## **Tech Note**

SI B 12 04 00

This Service Information bulletin supersedes S.I. 12 04 00 dated July 2000.

Secondary Air System Faults

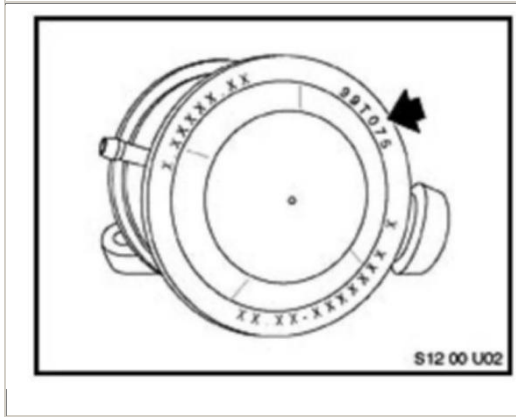
Improved Non-Return valves have been phased into production on all models.

A Non-return valve with a dated code stamping as of 99T075 (arrow) and later is the improved version. date cose explanation: 99=year, T=day, 075=75th day of the year.

Only the improved non-return valves are available from the Parts Distribution Centers.
